Subject: AP1000 Responses to Requests for Additional Information (SRP 3)

AP1000 TECHNICAL REPORT REVIEW

RAI Response Number: RAI-SRP3.7.1-SEB1-04

RAI Response Number: RAI-SRP3.7.1-SEB1-06
Revision: 2

Figure RAI-SRP3.7.1-SEB1-04-1 – X Seismic Response Spectra on Steel Containment Vessel at Elevation 224'

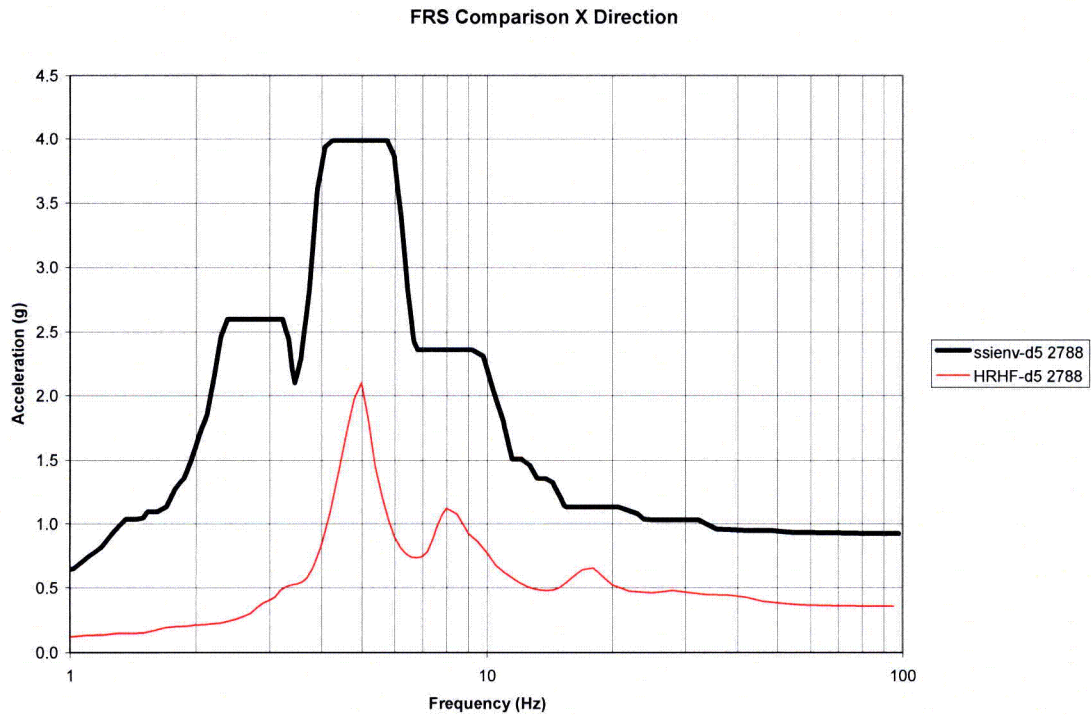
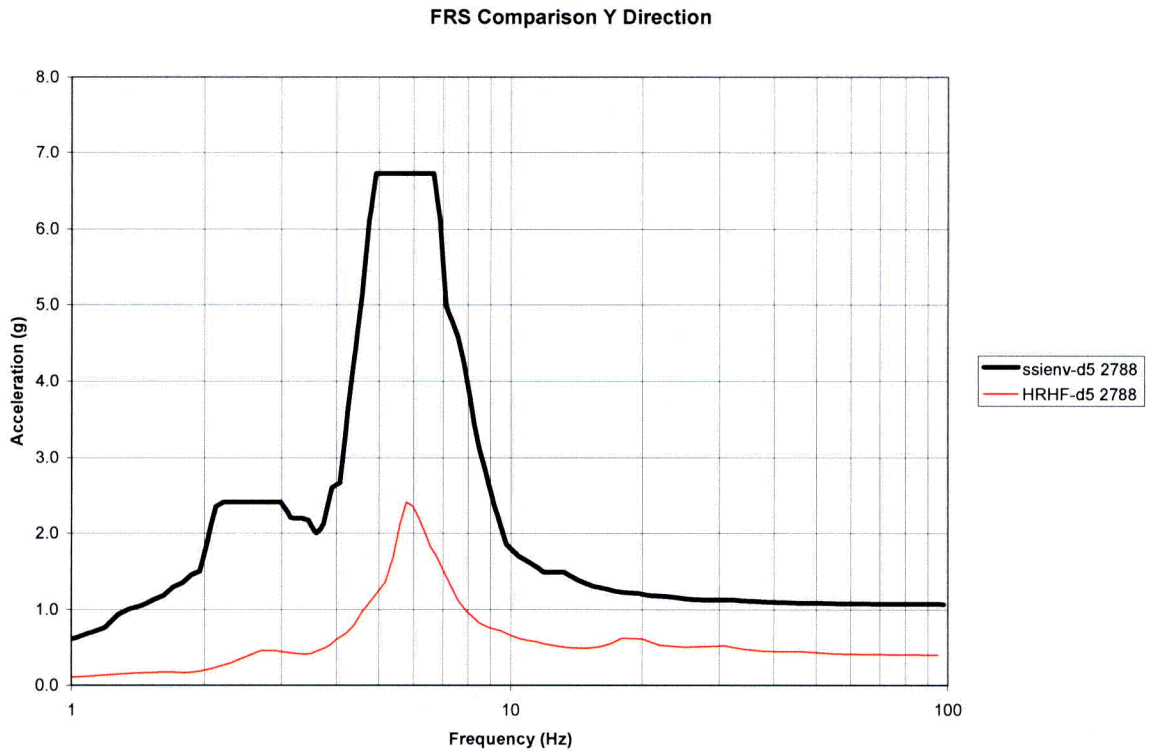
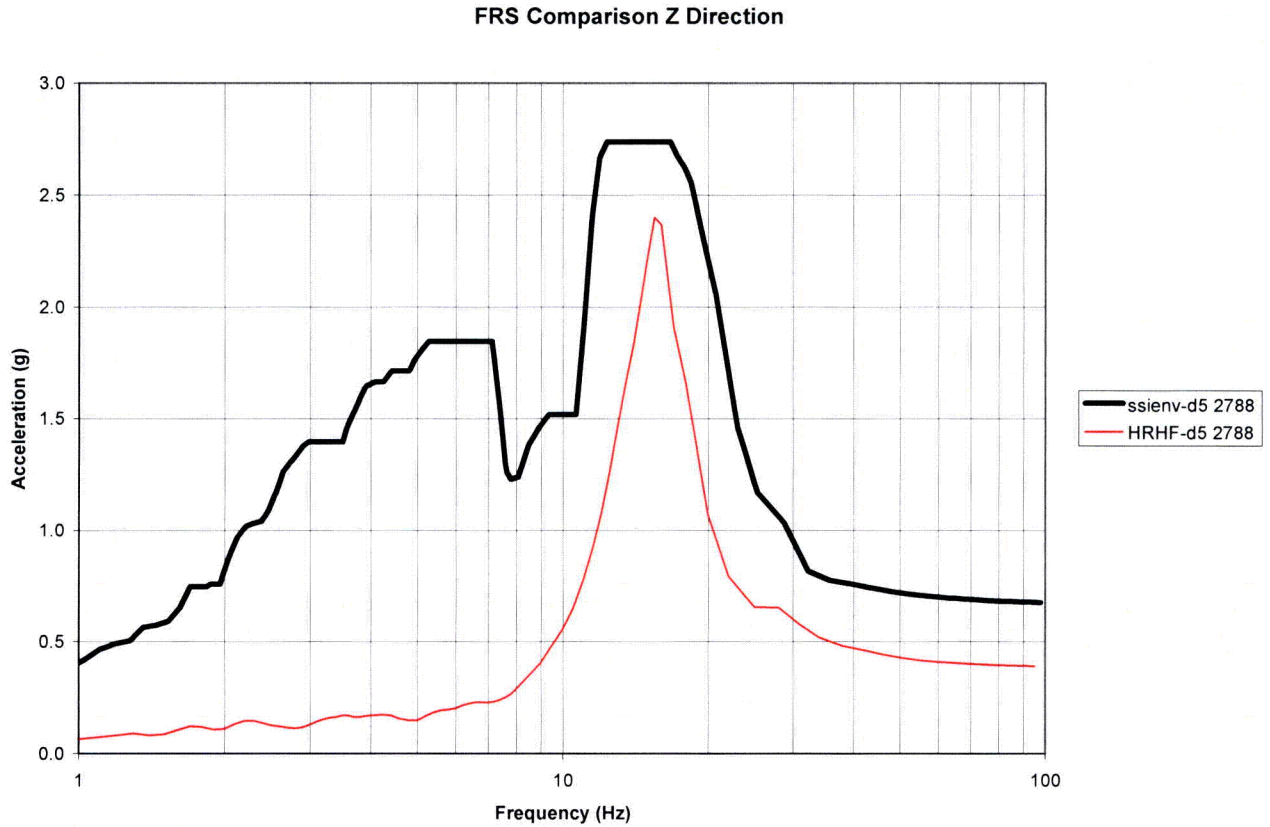
Based on information in DCD Rev. 16, Section 3G.2.1.3, in the discussion of the containment stick model response vs. the containment shell model response, Westinghouse identifies modes in the upper closure dome in the 23 to 30 Hz range. In addition, the modal properties of the attached water weirs and the air baffle attachments are identified to be in the same frequency range. Westinghouse justified the adequacy of the containment stick model on the basis that these high frequency modes in the containment dome and attachments would NOT be excited by the CSDRS (modified RG 1.60 spectra), because the CSDRS has no energy in this frequency range. While this may be adequate justification for use of a stick model for analysis of the steel containment shell response to the CSDRS, the staff notes that the HRHF GMRS has significant energy in 20-30 Hz frequency range, and would be expected to excite the shell vibration modes in the upper closure dome.

Based in the information reviewed to date, the staff is concerned that Westinghouse did not select an adequate sample of structures locations, for demonstrating that the AP1000 structural responses due to the HRHF GMRS are enveloped by the structural responses due to the CSDRS. Since the upper closure dome of the steel containment shell will be excited by the HRHF GMRS, the staff requests that Westinghouse provide detailed results for the response of the steel containment shell, including the local flexible modes in the upper closure dome, due to seismic excitation by the HRHF GMRS, and compare it to the design-basis CSDRS response, for both a stick model representation and a shell model representation of the steel containment shell.

The seismic response spectra in the vicinity of the polar crane (~224' elevation) is representative of the seismic response that the upper closure dome and the attached water weirs and air baffle attachments will experience. These floor response spectra (5% damping) are shown in Figures RAI-SRP3.7.1-SEB1-04-1 to RAI-SRP3.7.1-SEB1-04-3. As seen from these spectra comparisons, the CSDRS floor response spectra identified as SSIENV envelop the HRHF floor response spectra. Therefore, it can be stated that the items identified (upper closure dome, water weirs and the air baffle attachments) will have lower response due to HRHF response than that obtained from the CSDRS excitation.

It is true that the upper closure dome is in the 23 to 30 Hz range. However, as seen in Figures RAI-SRP3.7.1-SEB1-04-1 to RAI-SRP3.7.1-SEB1-04-3 the dominant frequency is below 10 hertz for the horizontal directions, and below 20 hertz in the vertical direction. The high frequency motion will be filtered, and there will be no significant energy to excite the higher modes in the 23 to 30 hertz range. The filtering of the high frequency motion is seen in the RAI figures. Westinghouse has selected an adequate sample of structural locations for demonstrating that the AP1000 structural responses due to the HRHF GMRS are enveloped by the structural responses due to the CSDRS.

Figure RAI-SRP3.7.1-SEB1-06-1: X-Direction Comparison

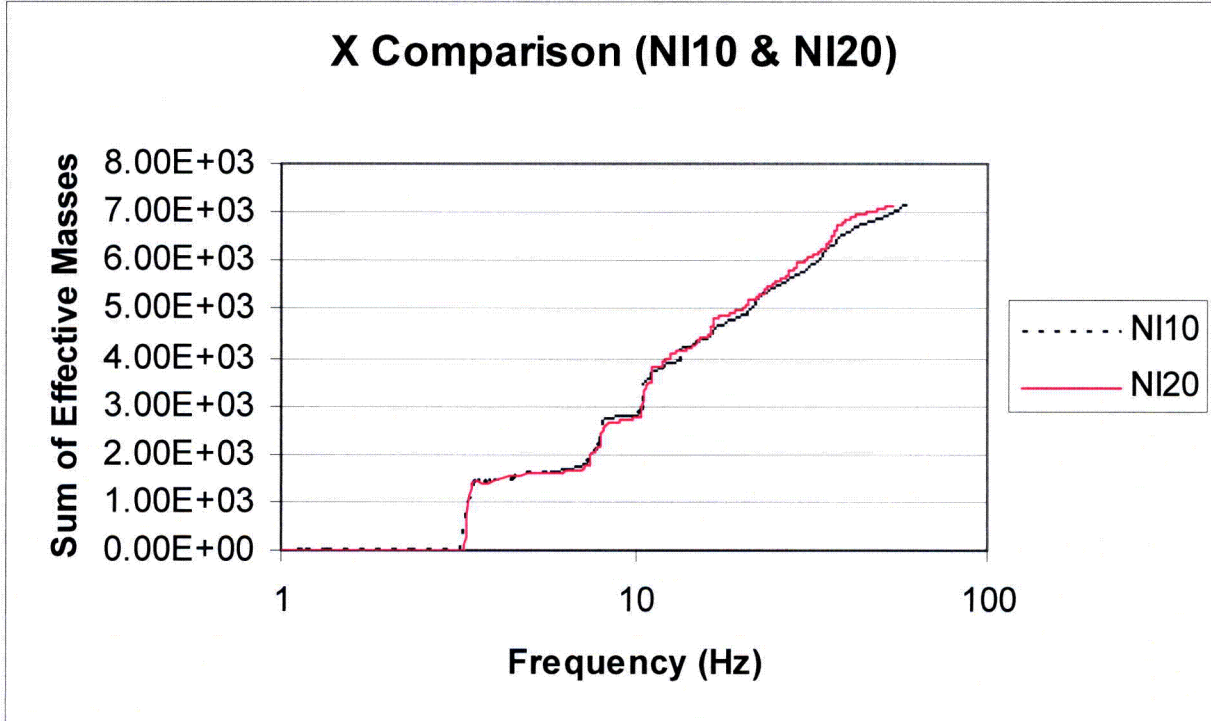
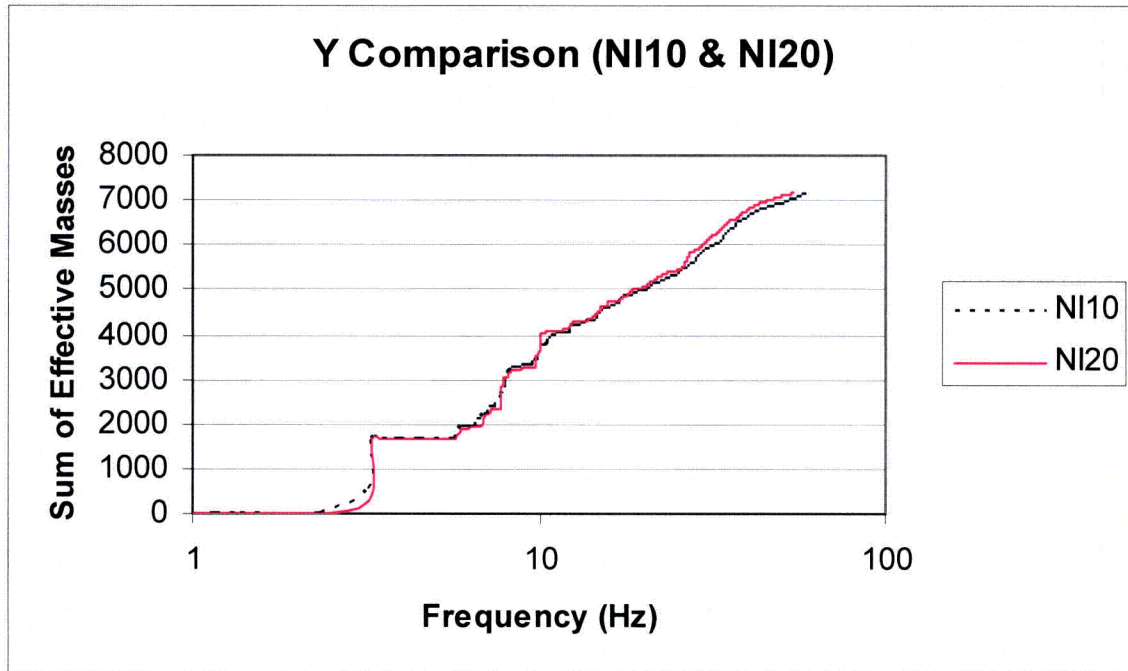
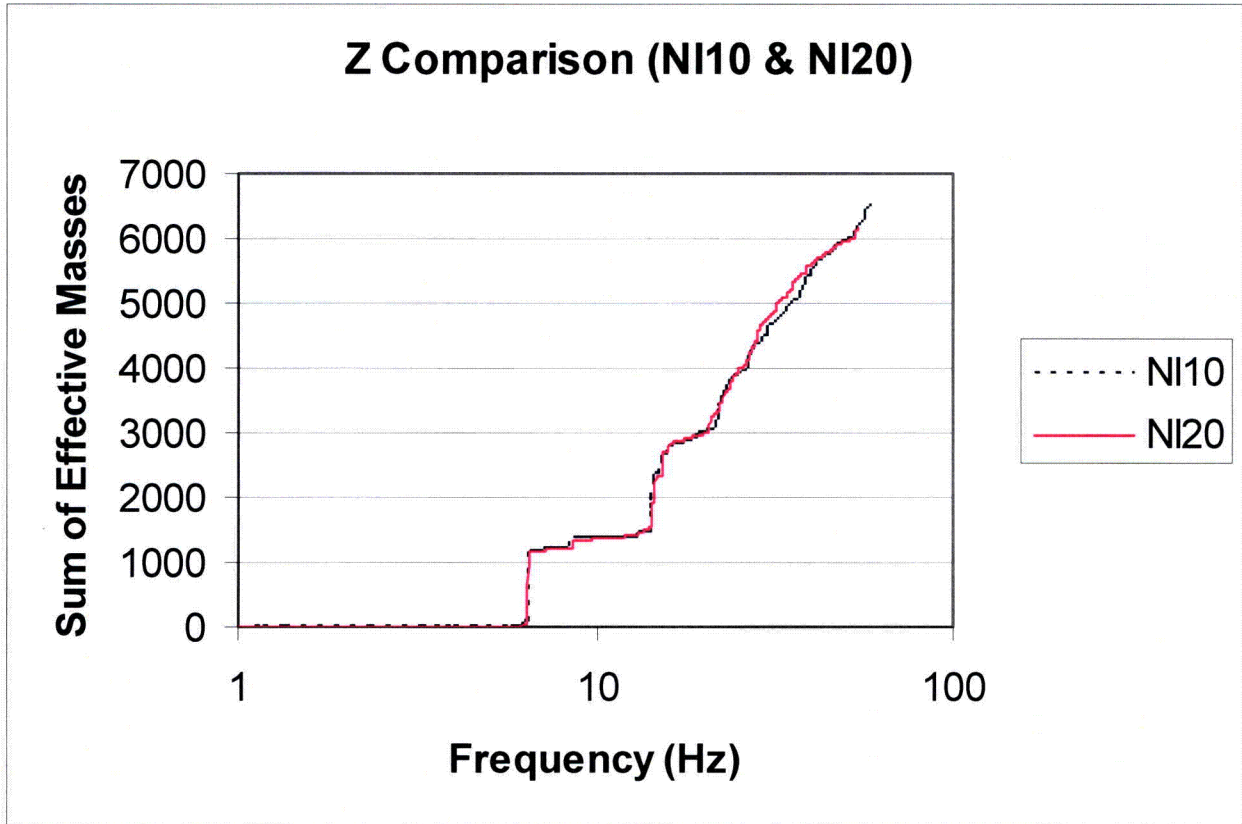
The staff initially requested that Westinghouse include in Section 5.1 of TR 115, a comparison of frequencies and mode shapes between the NI10 and NI20 models, as an alternate way to demonstrate the adequacy of the NI20 model to accurately predict high frequency modes (up to 80 Hz). In its initial response, Westinghouse pointed out that the final ISG for addressing HRHF GMRS, only requires modeling refinement to accurately predict up to 50 Hz. Instead of providing a comparison of frequencies and mode shapes between the NI10 and NI20 models up to 50 Hz, Westinghouse indicated that there are 7 nodes per wavelength in the NI20 model for a 50 Hz frequency. In a supplement to its initial response, as a result of discussions at the May 2008 onsite audit, Westinghouse presented additional information about the frequency distributions in the NI10 and NI20 models, and claimed that this information demonstrated adequacy of the NI20 model up to 50 Hz.

The staff reviewed this information and concluded (1) it does not demonstrate adequacy of the NI20 model up to 50 Hz; and (2) the information raises additional concern about the possibility of modeling and/or analysis errors.

- (a) In the 0-10 Hz range, there are 58 modes for NI20 and 69 modes for NI10. In the low frequency range, the correlation would be expected to be near 100%.
- (b) In the 10-40 Hz range, the difference in number of modes is very large: 658 for NI20; 1234 for NI10.
- (c) In the 40-55 Hz range, the difference in number of modes is relatively small: 484 for NI20; 545 for NI10.

Figures RAI-SRP3.7.1-SEB1-06-1 to RAI-SRP3.7.1-SEB1-06-3 show a summation of the of the effective mass verses frequency for the X, Y and Z directions. The effective masses associated with the NI20 and NI10 models compare closely over the frequency range of 1 to 80 Hz.

The difference in the number of modes between the NI10 and NI20 models is due to the increased number of degrees of freedom in the NI10 model. Therefore, it is expected that the NI10 model will have more modes within given frequency ranges. It is not possible to easily provide direct comparisons of the mode shapes between the two shell models because of their complexities and size. The best demonstration that the models are responding in a similar manner is by the comparison of modal mass over the frequency range of interest. This comparison has been provided in Figures RAI-SRP3.7.1-SEB1-06-1 to RAI-SRP3.7.1-SEB1-06-3. As seen from the comparison plots the modal response is the same in both models demonstrating the modal response will be similar.
